FIELD SERVICE BULLETIN

No. 9

EXHAUST TAIL PIPE WELD REWORK

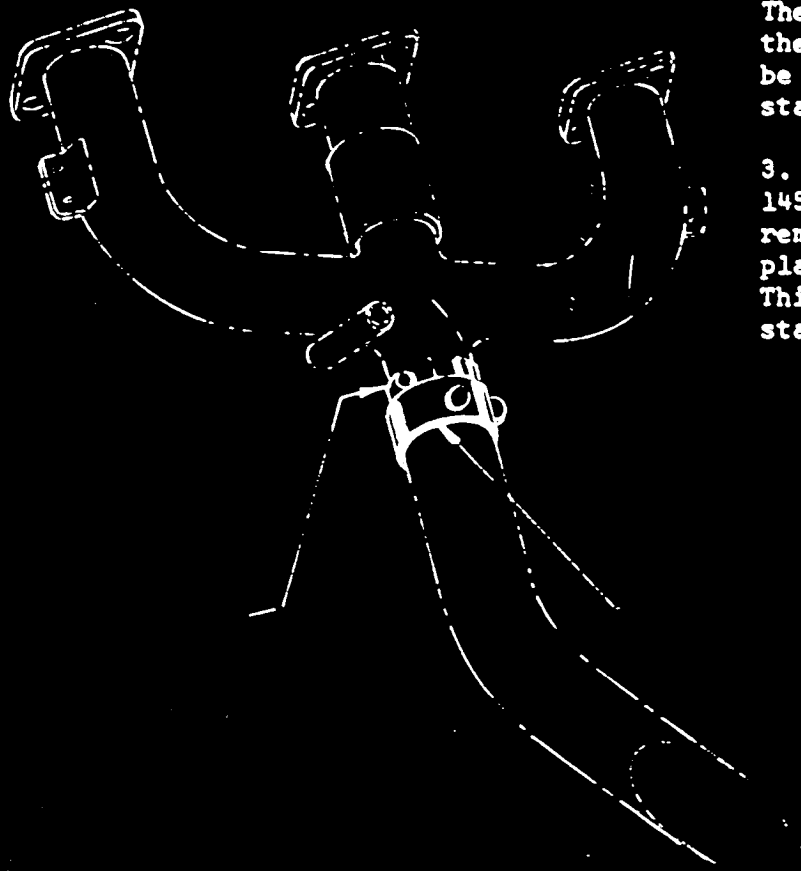
The following inspection should be made to the welded spot beads on the exhaust stacks to ensure security of the stacks.

1. Remove 145-42101-60 outer shroud from both right and left 145-42101-67 collector assemblies.

NOTE: It will be necessary to remove 145-53301-55 vent duct on the right side of the engine compartment, before removal of the right shroud can be accomplished.

2. Inspect the upper edge of 145-42101-51 and -52 exhaust stack tail pipes, for two welded spot beads. These beads should appear just above the 145-42104 clamp. The beads should be on the face and aft side of the stack and approximately 3/32 inch high.

3. If the beads do not exist, the 145-42101-51 and -52 stacks should be removed and two gas-welded spot beads placed on the upper edge of the stack. This bead is necessary to prevent stack from slipping from under clamp.
